ACCESSION NBR:8901030398 DOC.DATE: 88/12/29 NOTARIZED: NO DOCKET #
 FACIL:50-316 Donald C. Cook Nuclear Power Plant, Unit 2, Indiana & 05000316
 AUTH.NAME AUTHOR AFFILIATION
 ALEXICH,M.P. Indiana Michigan Power Co. (formerly Indiana & Michigan Ele
 *RECIP.NAME RECIPIENT AFFILIATION
 MURLEY,T.E. Document Control Branch (Document Control Desk)

SUBJECT: Clarifies previous submittals re control room ventilation sys.

AEP:NRC:0914E

Donald C. Cook Nuclear Plant Units 1 and 2
Docket Nos. 50-315 and 50-316
License Nos. DPR-58 and DPR-74
MODIFICATION OF SUBMITTALS REGARDING CONTROL ROOM VENTILATION

FIGURE 1

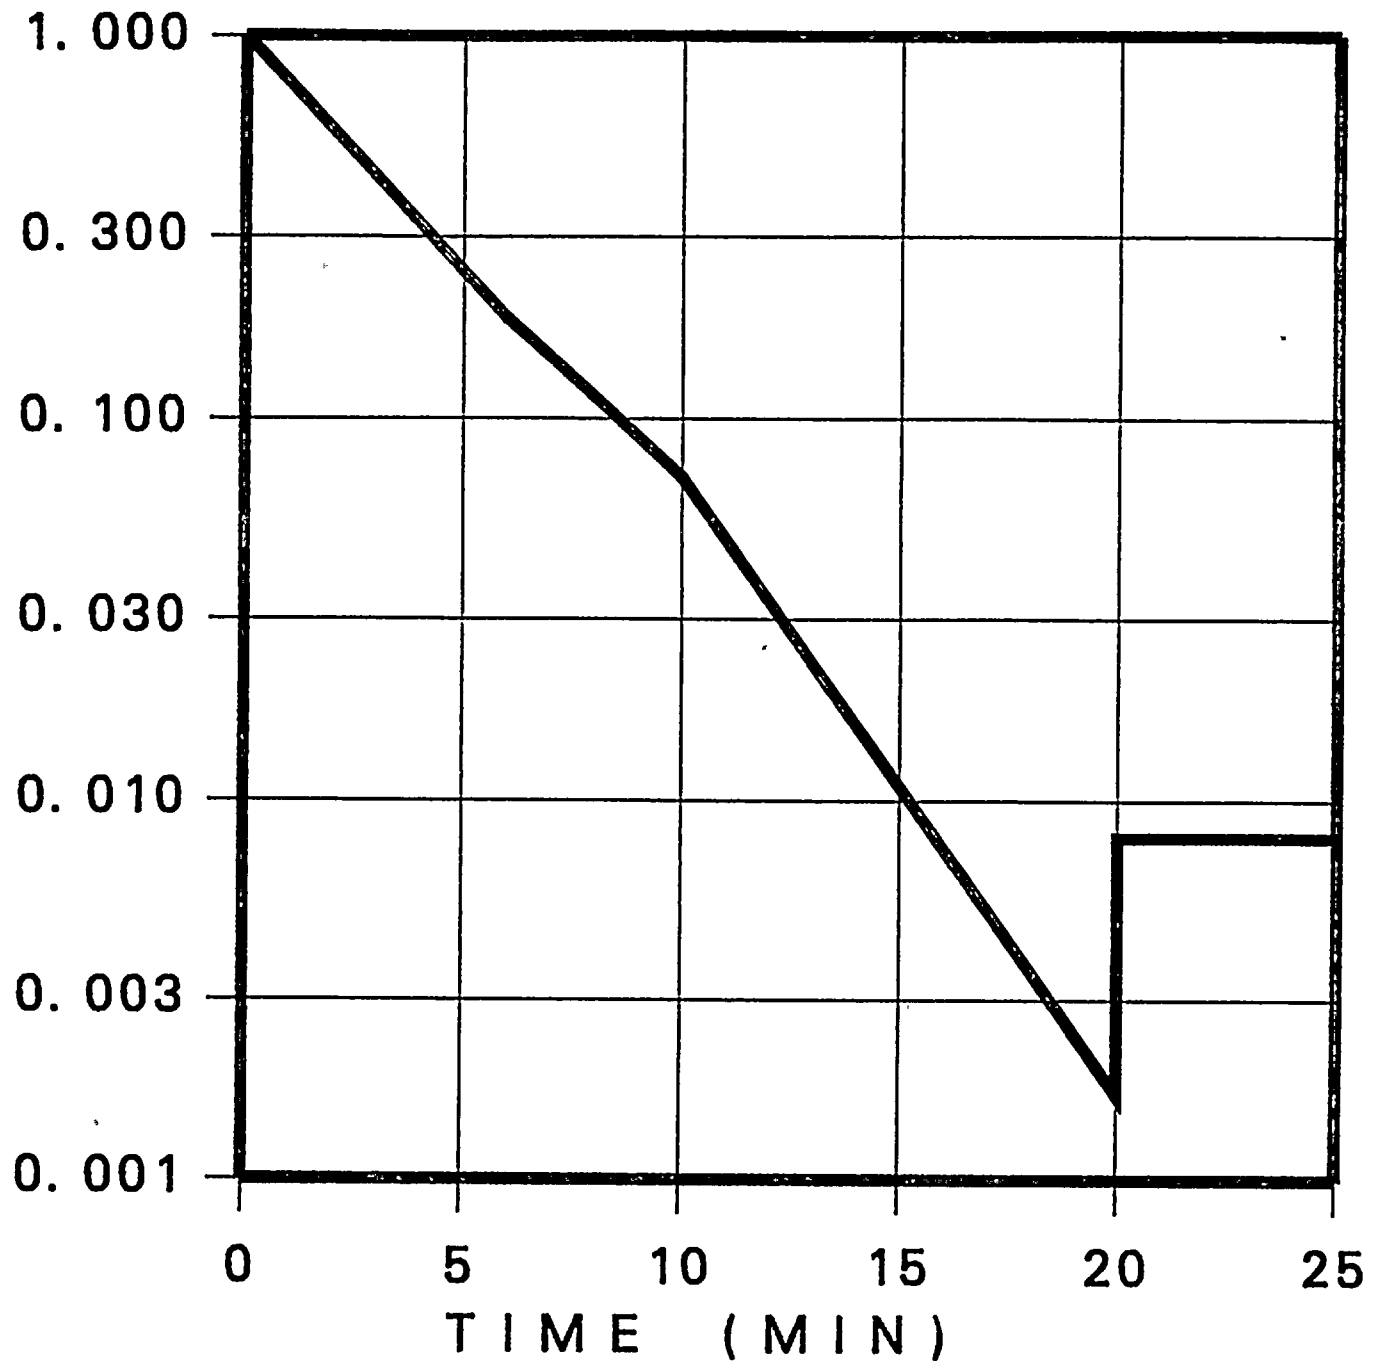
In the calculations that supported the October 11, 1988 submittal, half of the iodine originally present in the containment atmosphere was assumed to instantaneously plate out, as permitted by Section 8.3.2 of the ANS Standard. However, the DF limits used in the calculation were determined using the initial iodine concentration as that concentration after plateout occurred. This meant that the maximum elemental iodine DF was 400 rather than 200, and that the particulate removal constant was changed at a DF of 200, instead of 100.

removal was based on a conservative fit to Figure 14.3.5-1 of the Updated FSAR, rather than limited to 10 hr^{-1} as in the original calculation. The specific curve used in our control room reanalysis is provided in Figure 1. The particulate iodine removal coefficient was reduced to one tenth its original value after a DF of 100 was reached; removal continued at the reduced rate until the effect on dose became insignificant. In the original calculation, removal was assumed to stop at the removal rate reset setpoint.
